Report to the Future Melbourne Committee

**Planning Permit Applications: TP-2018-1005 and 46 others
Address: Various road reserves in Melbourne and Carlton**

16 May 2023

Proposed Site Plan of Cabinet 18 [Source: Applicant]

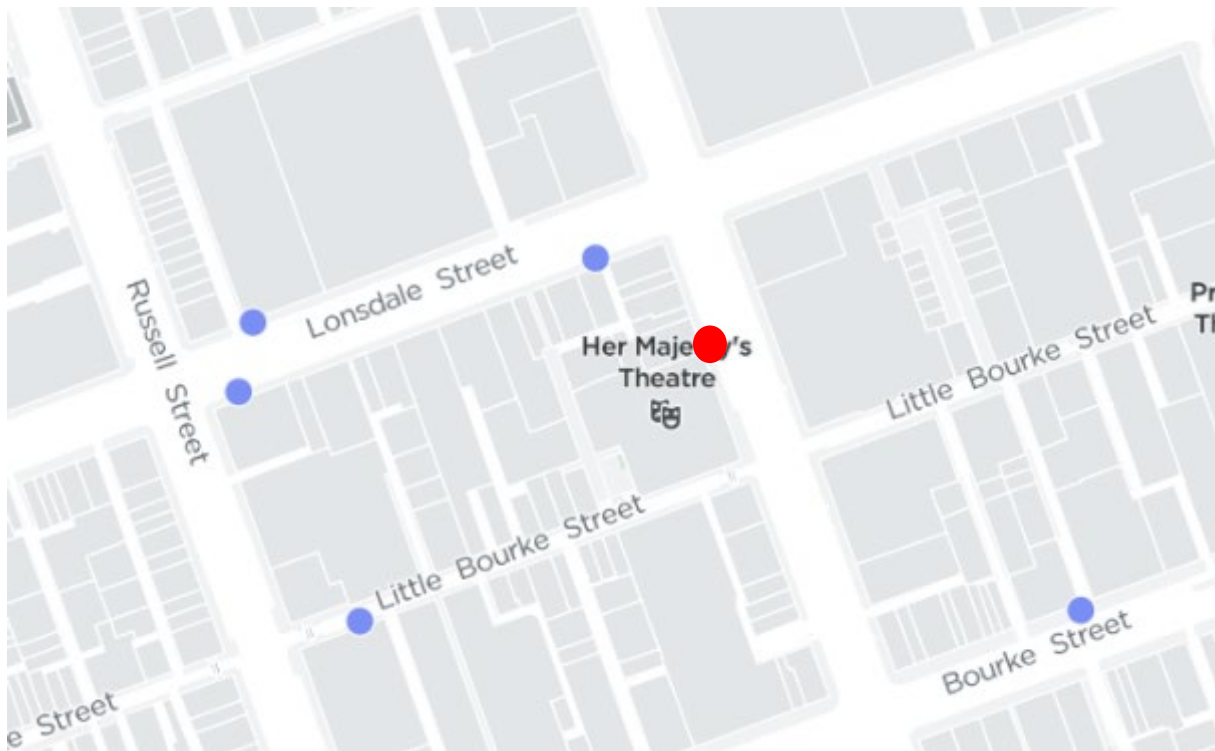
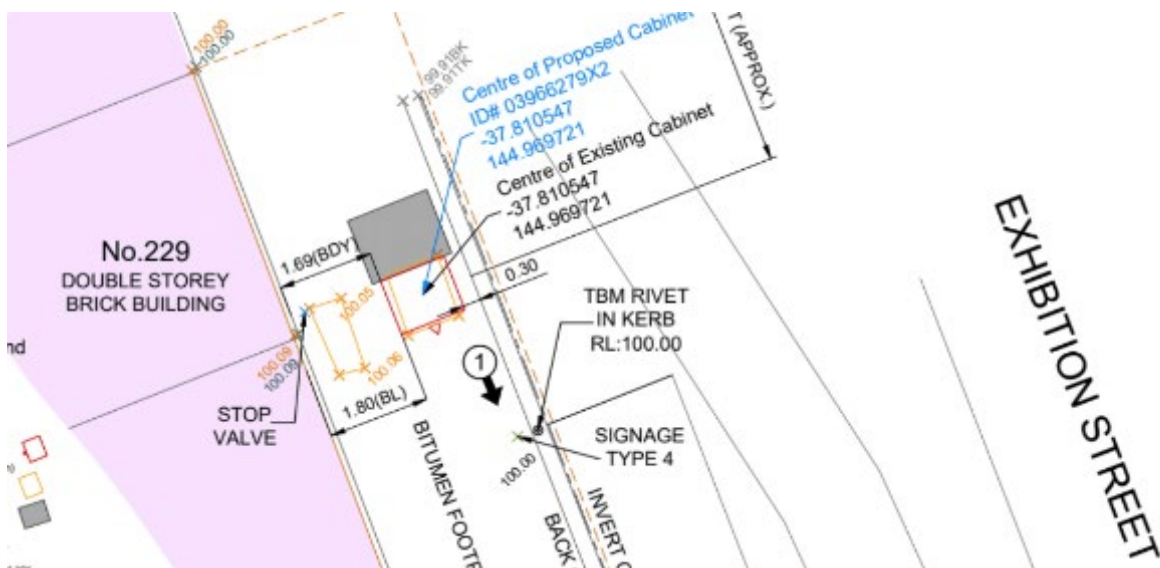
Pedestrian movement in this section of Exhibition Street can be high given the adjacent theatre. Other than the existing cabinet there is little if any other infrastructure that creates such an incursion into the pedestrian corridor of the footpath. Accepting only a marginal change from the existing cabinet, that structure was exempt from planning permission and to further entrench such a condition in perpetuity would be a poor outcome. The impacts on the pedestrian network are not acceptable.

Proposed Site Plan of Cabinet 22 [Source: Applicant]

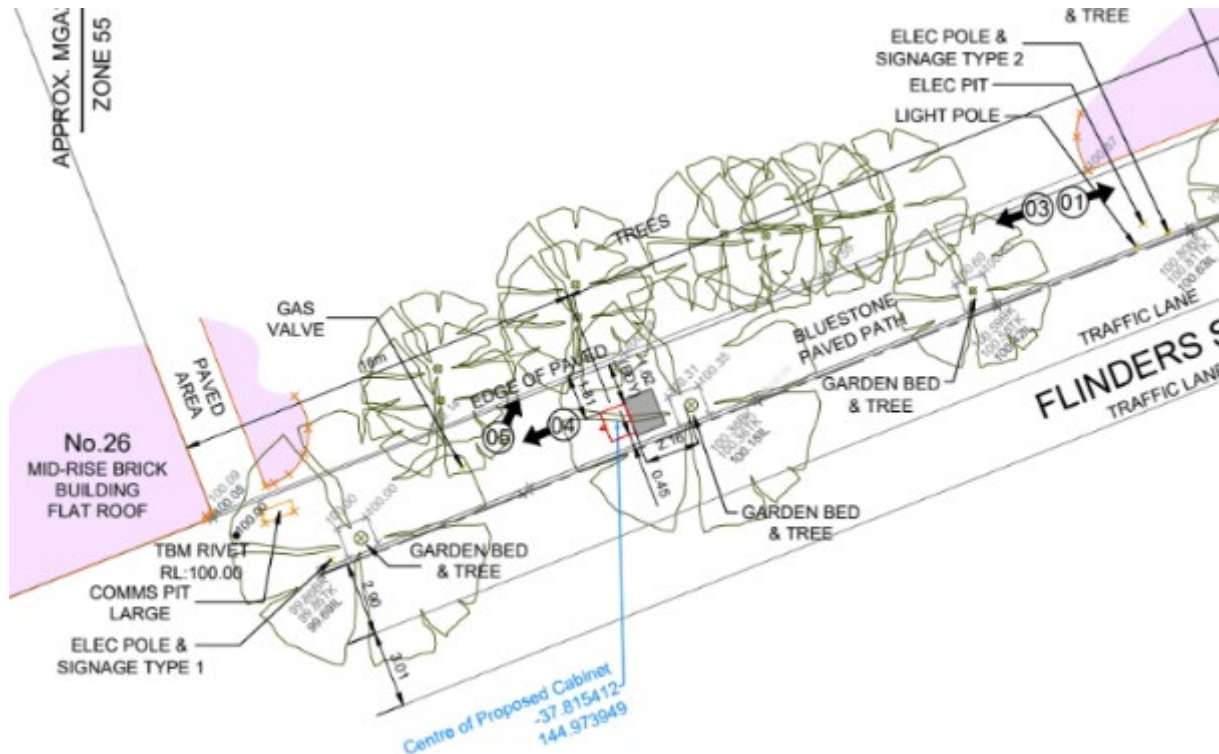
The resultant footpath width is inadequate for pedestrian movement, and while the adjacent open plaza has the effect of providing additional width, reliance on private realm land to provide the necessary clearance is not appropriate. The impacts on the pedestrian network are not acceptable.

Proposed Site Plan of Cabinet 24 [Source: Applicant]

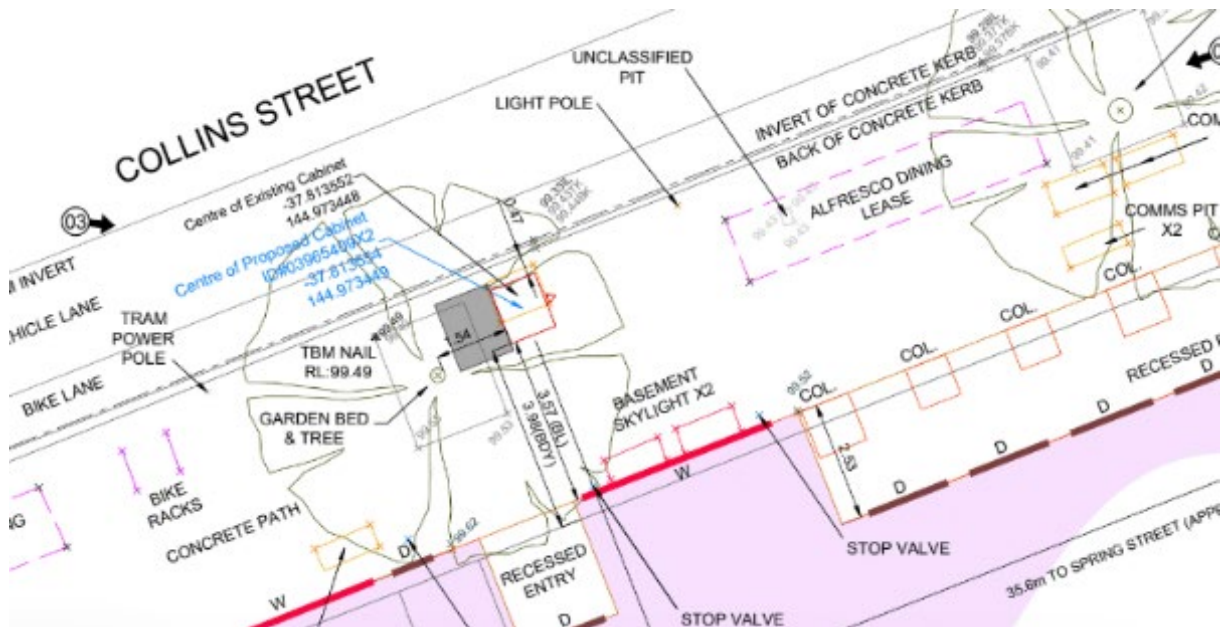
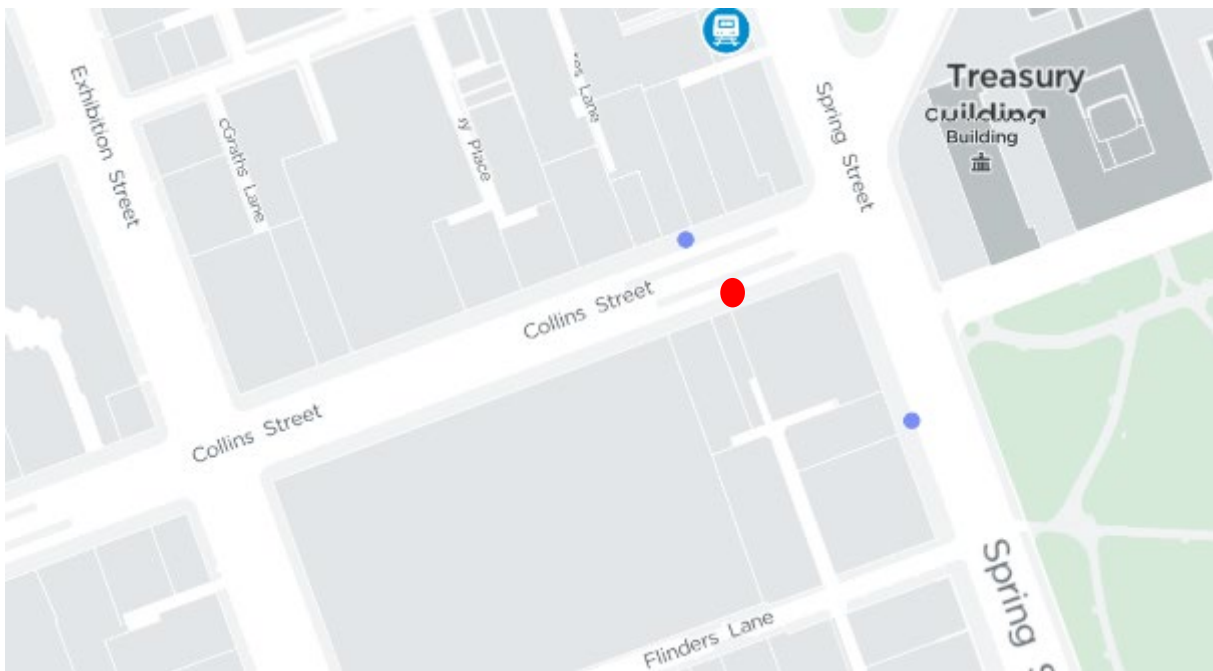
- Although the proposed cabinet will replace one which already displays as of right signage, this is a situation and sensitive heritage context (as outlined above) where the introduction of a larger electronic sign in close proximity to significant buildings is unacceptable.

Proposed Site Plan of Cabinet 25 [Source: Applicant]

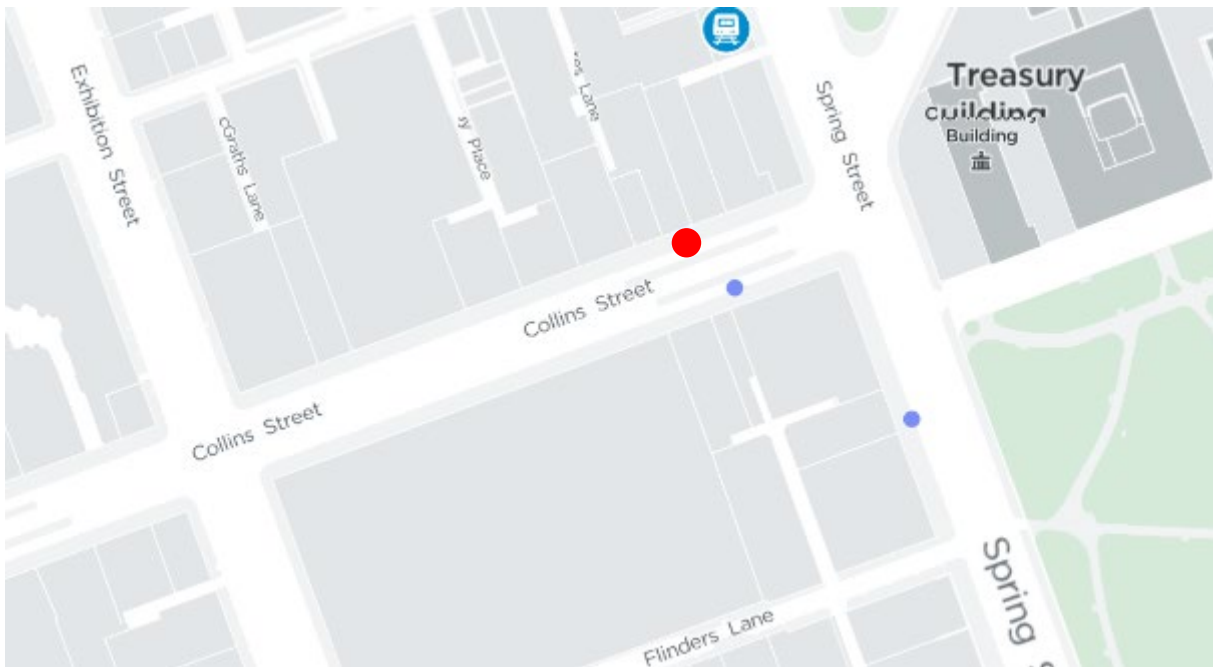
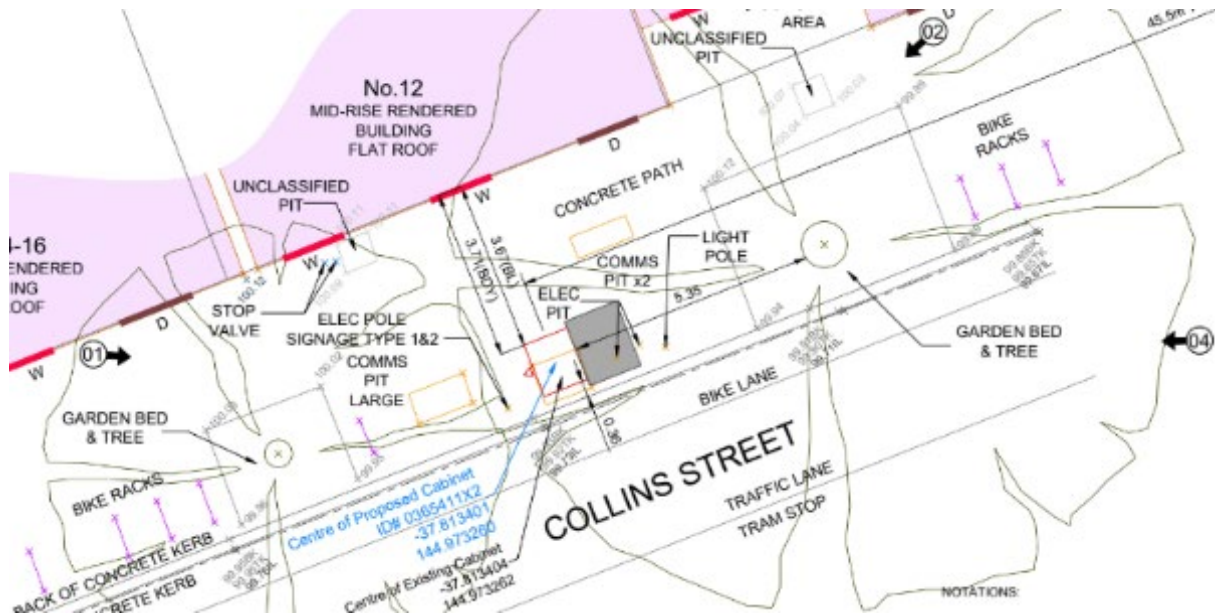
- Although the proposed cabinet will an existing cabinet, it did not require a planning permit. This application does require a planning permit and therefore an assessment of the sensitive heritage context is required (as outlined above). The introduction of a larger electronic sign in close proximity to significant buildings is unacceptable.

Proposed Site Plan of Cabinet 27 [Source: Applicant]

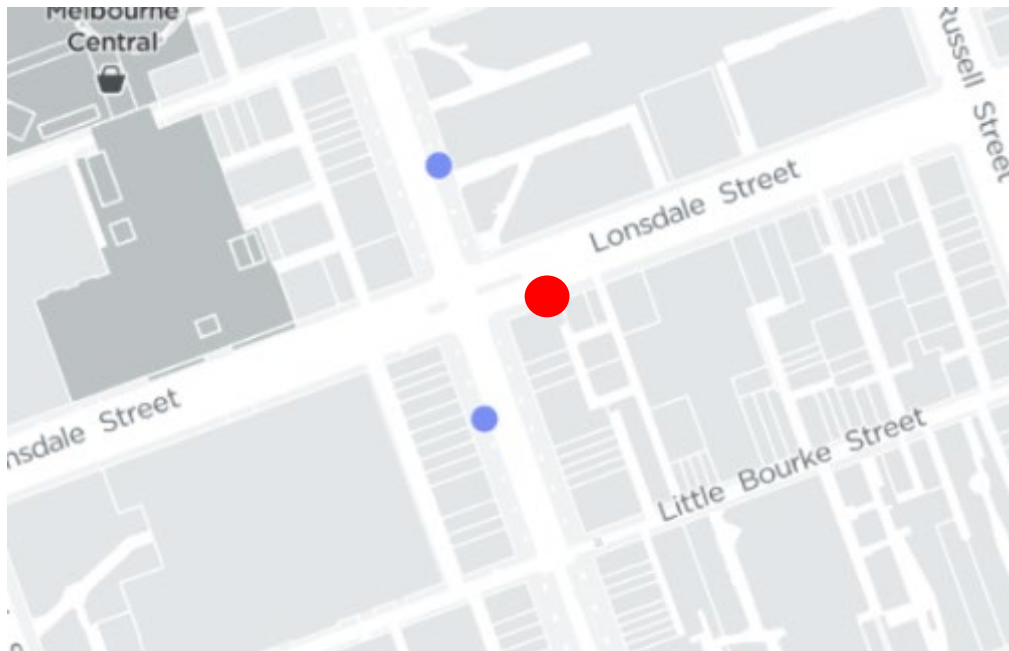
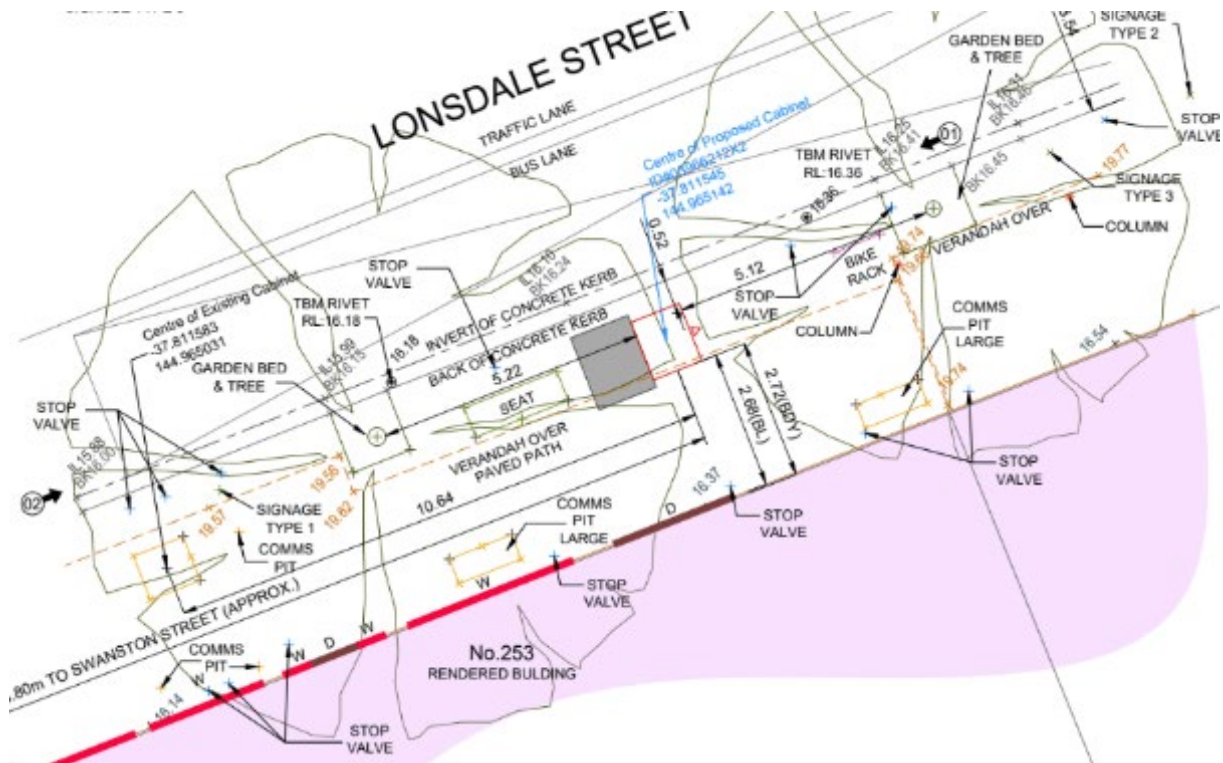
The proposed cabinet will be introduced to an already cluttered footpath environment, noting the existing cabinet (not noted for removal) is possibly the most disruptive piece of infrastructure. The new location will be disruptive to a public transport interchange. The cabinet will sit partially below the awning of the adjacent building with very little clearance. The adjacent building has its entry opposite the proposed location. Similar to Cabinet 18, the additional height of the structure will provide limited clearance and result in an enclosing of the public realm.

Proposed Site Plan of Cabinet 29 [Source: Applicant]

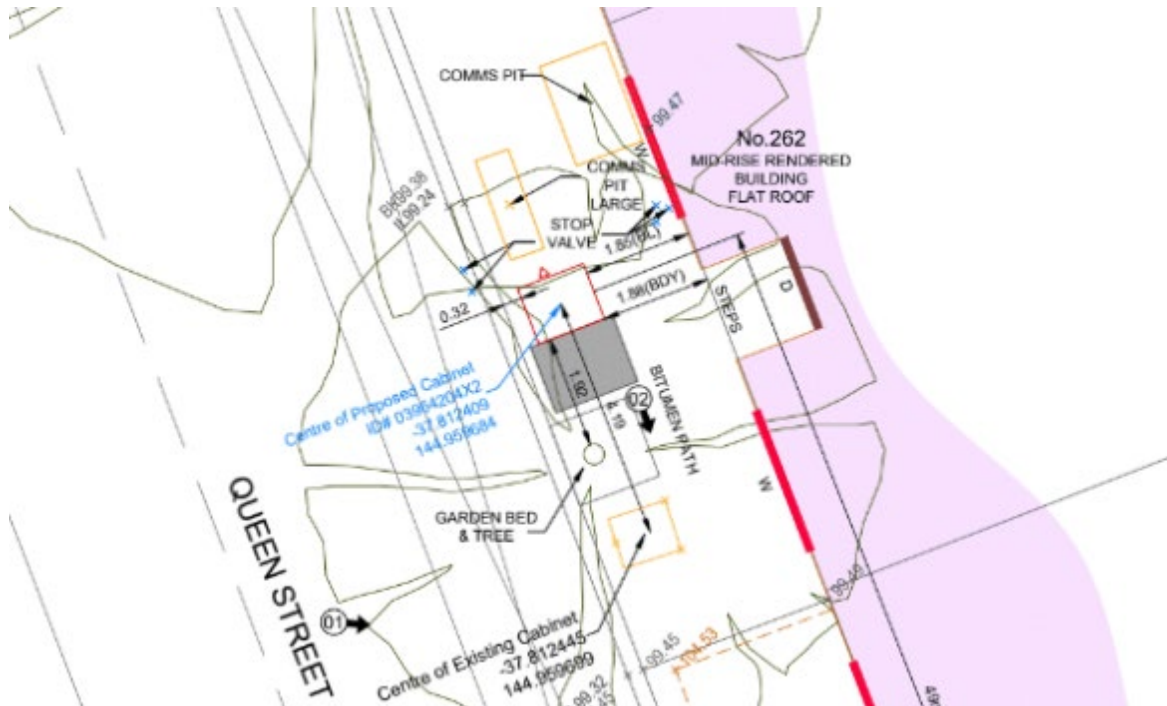
The proposed offset from the back of kerb at 320 mm is marginal and below the minimum requirements for Council infrastructure. The plans also indicate it will sit closer to the kerb alignment than the street tree and existing cabinet.

Proposed Site Plan of Cabinet 32 [Source: Applicant]

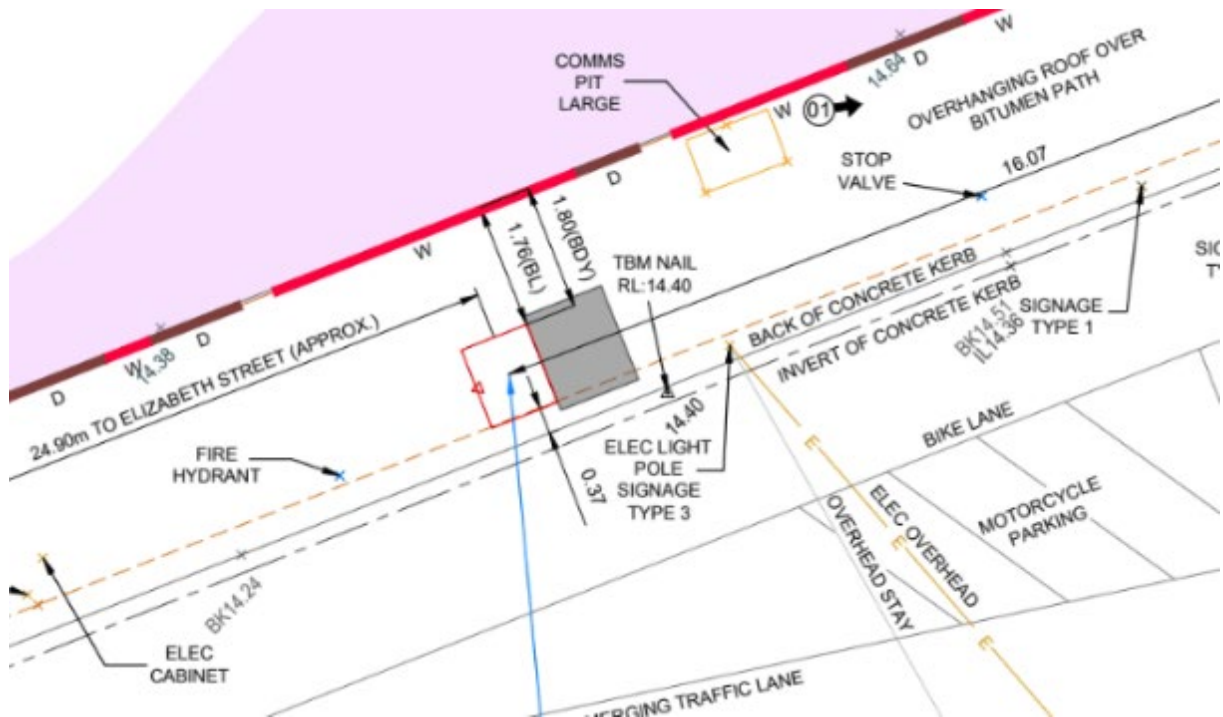
The proposal is to replace an existing cabinet located 16 metres to the east. This section of footpath is relatively narrow and the proposal will result in a footpath width of 1.8 metres from the adjacent property boundary (1.76 metres to the building line, being a solid wall). Pedestrian movement along this section of La Trobe Street is high given the Retail Core opposite (Melbourne Central), public transport interchanges and nearby RMIT University. Pedestrian volumes are anticipated to increase following the completion of State Library Station.
